RE: Site Plan Application for Portland IMT, Existing Laydown and Connecting Corridor Connection
Site Plan Addendum #5

COMMENTS FROM RICK KNOWLAND, SENIOR PLANNER (VIA PLANNING BOARD REPORT, JUNE 20, 2014) AND RESPONSES:

CHASSIS STORAGE YARD SURFACE DETAIL
NOT TO SCALE

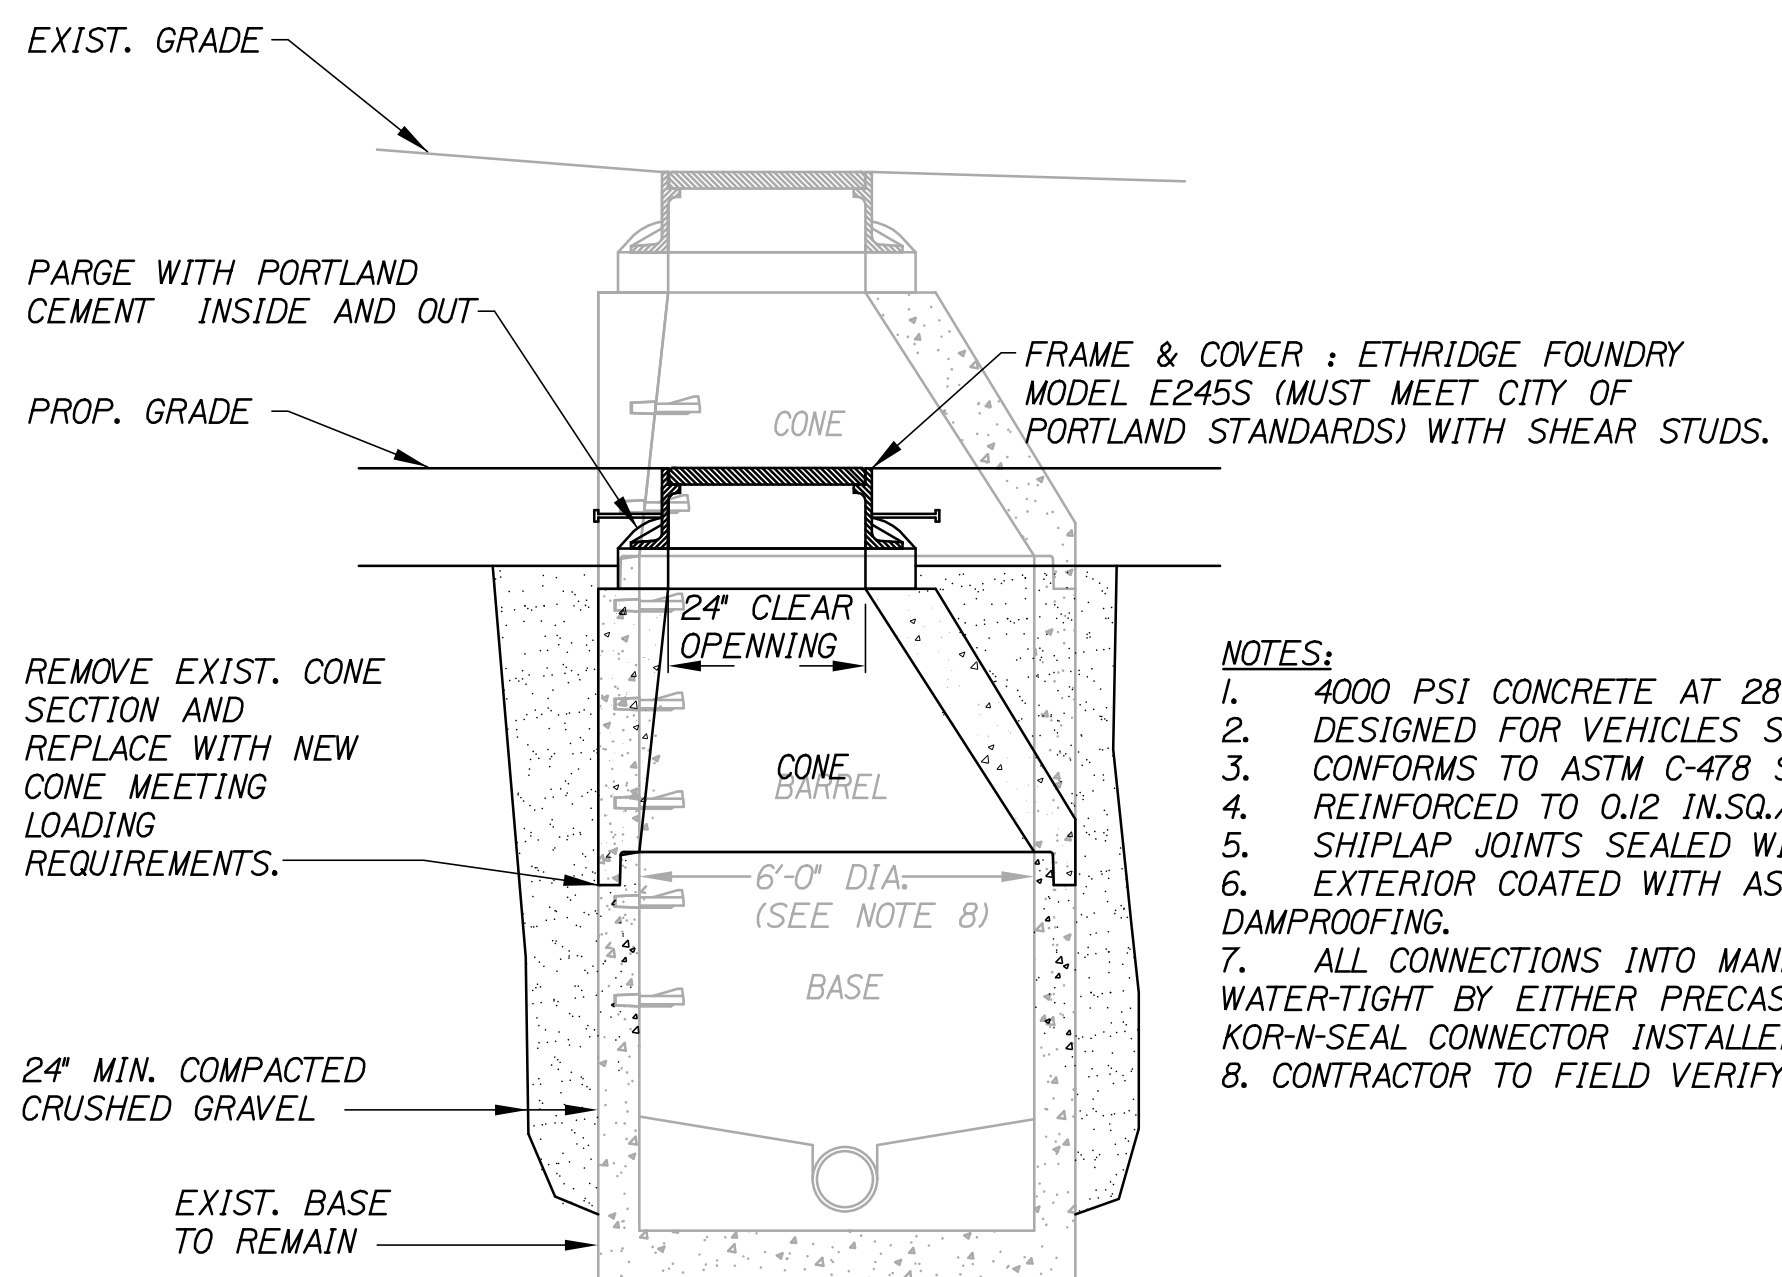
The plan should clarify where new gravel will be installed on the site including a cross section of the depth and type of material.

Response: Site Grading and Drainage Plan C09 shows the limits for the new granular improvements in the Chassis Storage Yard and Site Details C13 shows the typical section which will be used for this area (see Attachments A and E).
